ATTACHMENT 2

Markup of Technical Specification Pages

Figure 3.4.11-1 (Page 1 of 1)

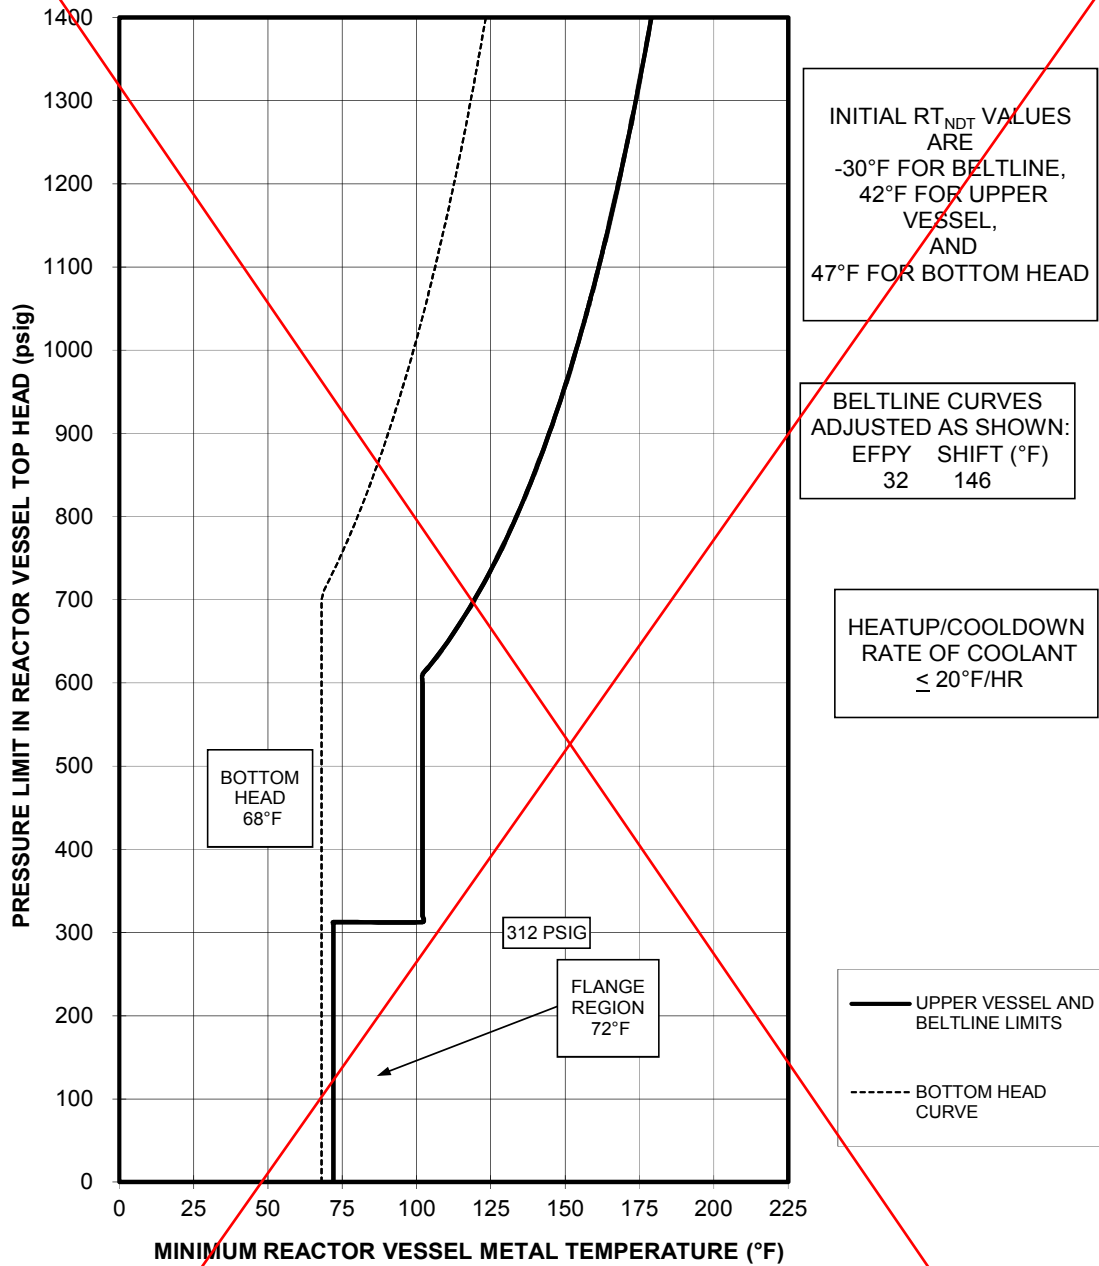
INFORMATION CONTAINED ON THIS PAGE HAS BEEN DELETED

Figure 3.4.11-2 (Page 1 of 1)
Unit 1

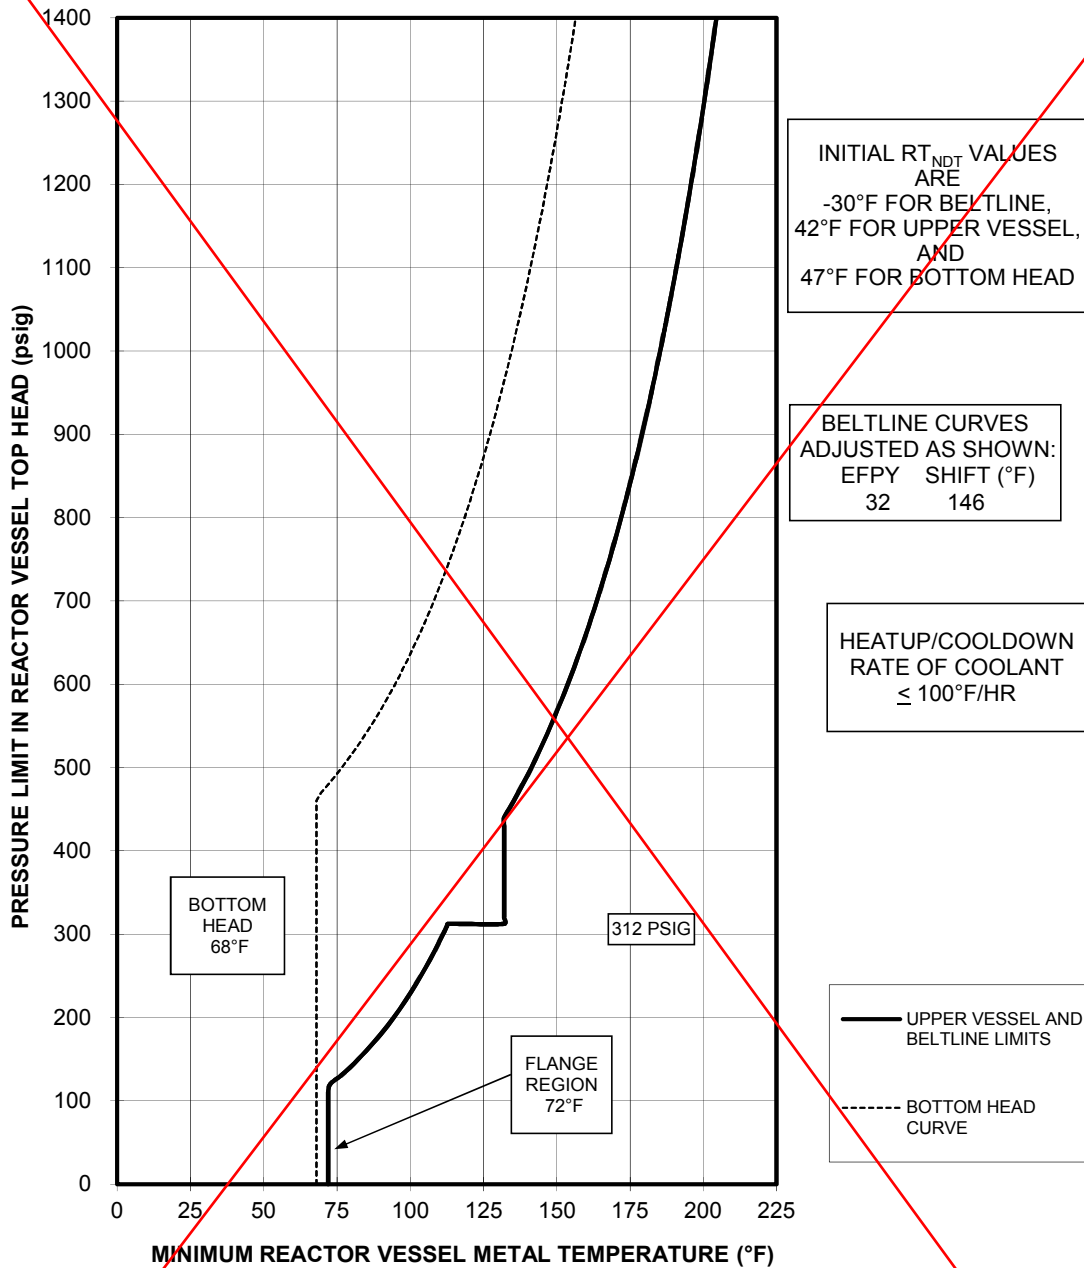
INFORMATION CONTAINED ON THIS PAGE HAS BEEN DELETED

Figure 3.4.11-3 (Page 1 of 1)
Unit 1

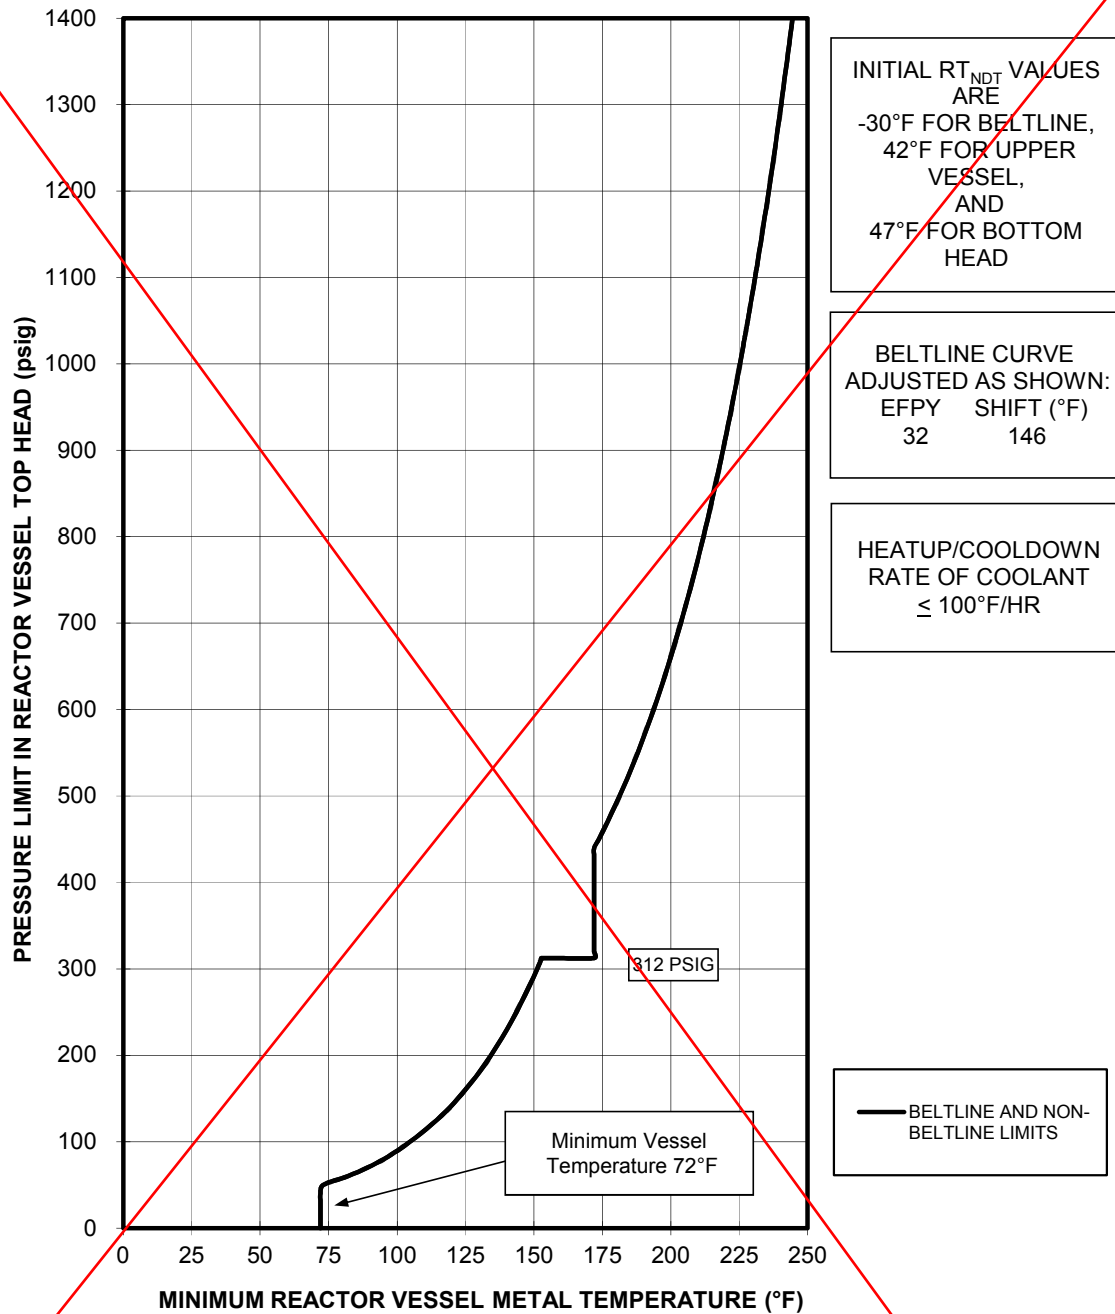
INFORMATION CONTAINED ON THIS PAGE HAS BEEN DELETED

Figure 3.4.11-4 (Page 1 of 1)
Unit 2

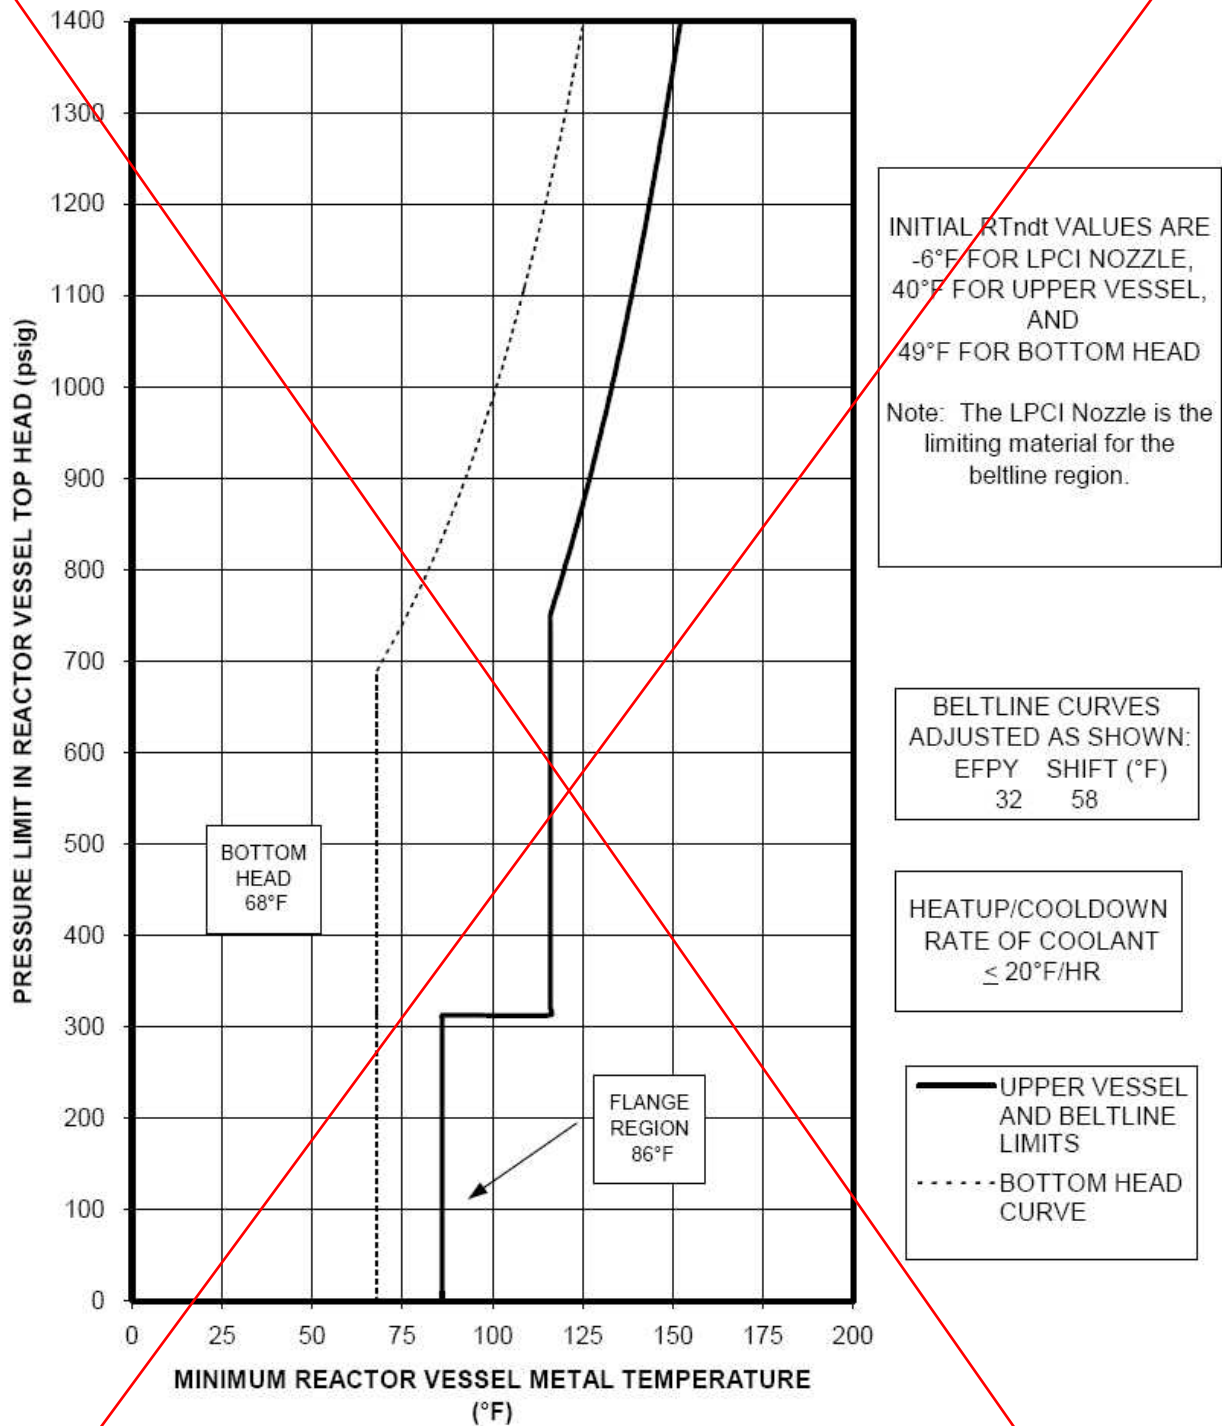
INFORMATION CONTAINED ON THIS PAGE HAS BEEN DELETED

Figure 3.4.11-5 (Page 1 of 1)
Unit 2

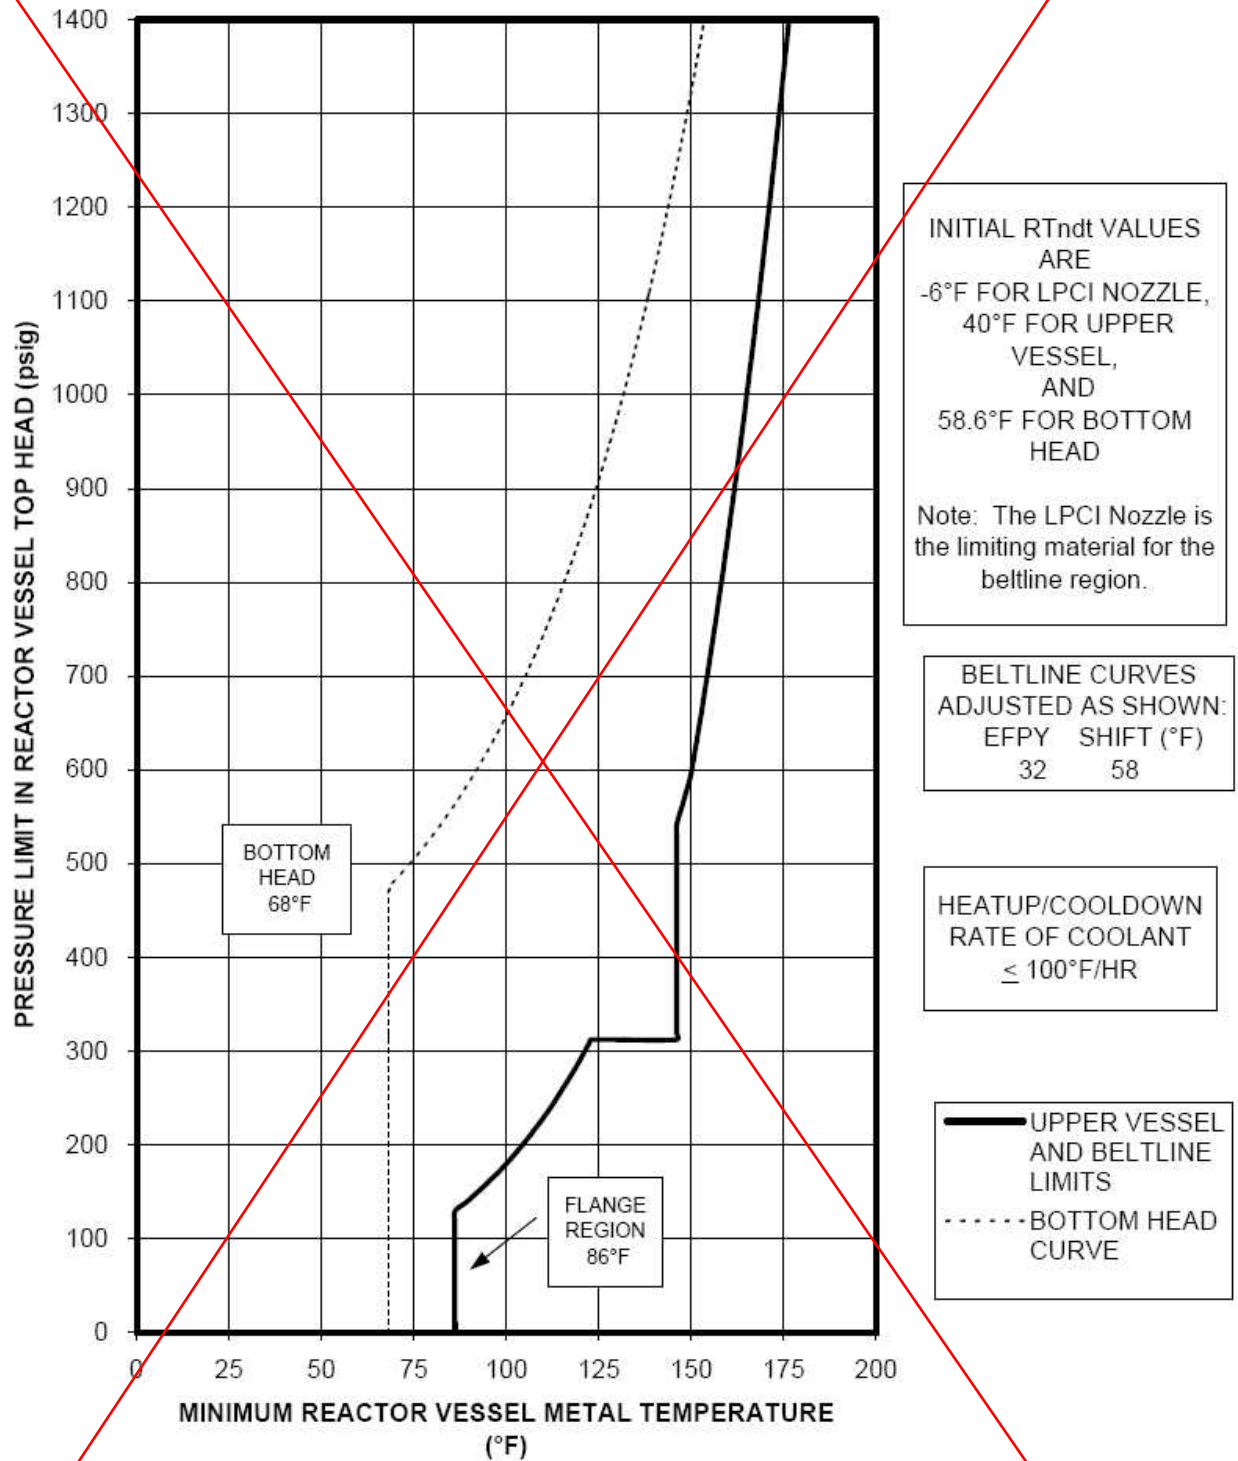
INFORMATION CONTAINED ON THIS PAGE HAS BEEN DELETED

Figure 3.4.11-6 (Page 1 of 1)
 Unit 2
 P-T Curves for Operation with a Core Critical
 other than Low Power Physics Testing up to 32 EFPY

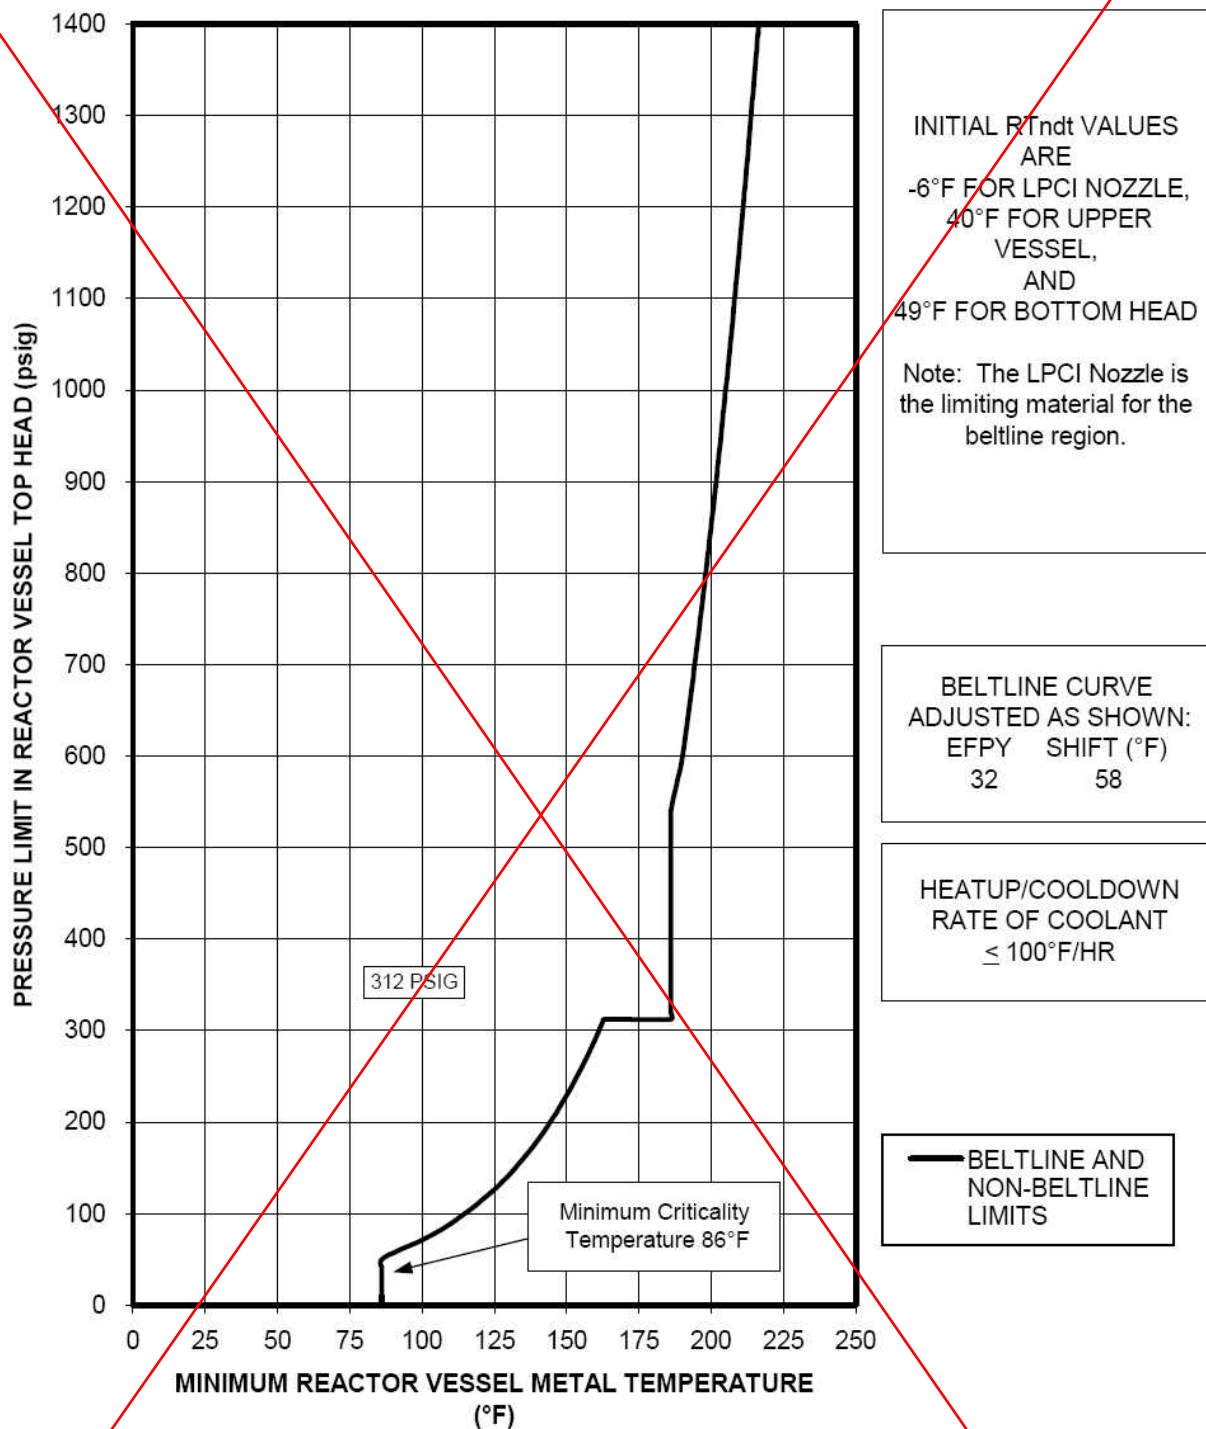
INFORMATION CONTAINED ON THIS PAGE HAS BEEN DELETED
